**Commentor No. 232 (cont'd): Susan Burke, INL Coordinator,  
Idaho Department of Environmental Quality**

Re: Draft Tank Closure and Waste Management Environmental Impact Statement  
for the Hanford Site, Richland, Washington

The Idaho Department of Environmental Quality (DEQ) has reviewed the above titled document (draft EIS) and has the following comments:

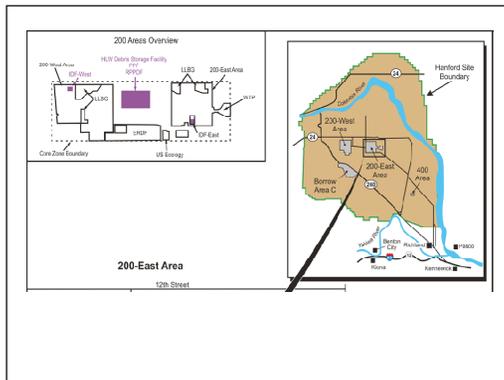
- Hanford Reach of the Columbia flows through Hanford for over 50 miles, past nine full scale nuclear reactors, hundreds of liquid waste and burial sites.
- Hanford Reach National Monument
- Contaminants already entering River along shore at levels >1,500 times Drinking Water Standard (Strontium-90)

See response to comment 250-2 for information about the sensitivity analysis performed by DOE for this EIS.

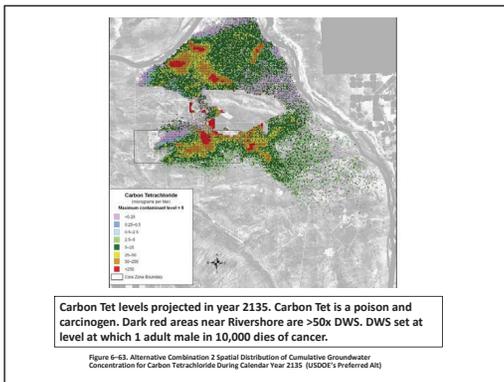
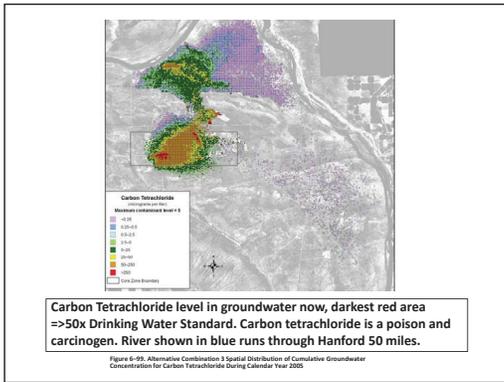
- Whether USDOE will Clean-Up the High-Level Nuclear Waste Tank Leaks and the Billions of Gallons of Tank Wastes Deliberately Discharged into Soil Ditches (Cribs, Trenches)?
- Whether to remove the tanks and piping or add cement and leave behind under a "cap"?
- "Tank Closure" decisions
- USDOE wants to use "landfill" closure: Not investigate contamination; add cement; Not cleanup leaks and discharges – put big soil caps over tank farms
- Hazardous waste law says use "clean closure": must take all practical steps to remove residues; and, investigate and cleanup contamination before capping.

As analyzed in this *TC & WM EIS*, 67 of the 149 SSTs at Hanford are known or suspected to have leaked liquid waste to the environment between the 1950s and the present, some of which has reached the groundwater. Estimates of the total leak loss range from less than 2.8 million to as much as 3.97 million liters (750,000 to 1,050,000 gallons). DOE recognizes that groundwater contamination from past leaks is a concern at Hanford and its potential impact on communities downriver from Hanford. One of the purposes of this *TC & WM EIS* is to analyze potential impacts of DOE's proposed actions to retrieve waste from the buried tanks, treat and dispose of this waste, and close the SST farms. This analysis is also intended to aid DOE in making decisions regarding cleanup of the past leaks, including remediation of the contamination in the vadose zone.

Figure 6-66. Alternative Combination 3 Spatial Distribution of Cumulative Groundwater Concentration for Uranium 238 During Calendar Year 2135

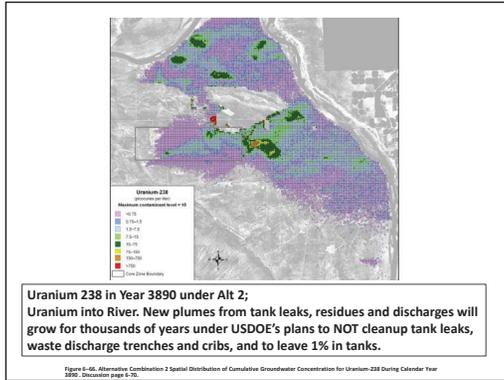
**Uranium 238 in Groundwater in Year 2135**  
Dark red >50x Drinking Water Standard

accordingly in this *Final TC & WM EIS*. For a more comprehensive discussion of the age and accuracy of data, see Section 2.2 of this CRD.

Figure 6-66. Alternative Combination 2 Spatial Distribution of Cumulative Groundwater Concentration for Uranium-238 During Calendar Year 3890 . Discussion page 6-70.

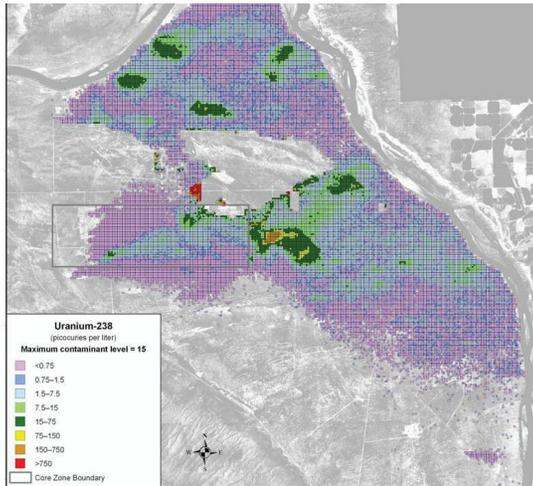
Uranium 238 in Year 3890 under Alt 2 - Uranium into River:

Note that the area USDOE uses to report groundwater contamination levels is what it refers to as the "Core Zone Boundary", shown in charts as the box on the Central Plateau. This exceeds the 200 Area fence lines, and is a significant distance from the boundaries of the regulated hazardous waste units – allowing for significant dilution in groundwater before reaching the location USDOE is reporting on. Hazardous waste laws, however, require meeting the drinking water standard at the boundary of the unit itself – not allowing USDOE to contaminate large areas outside the units.
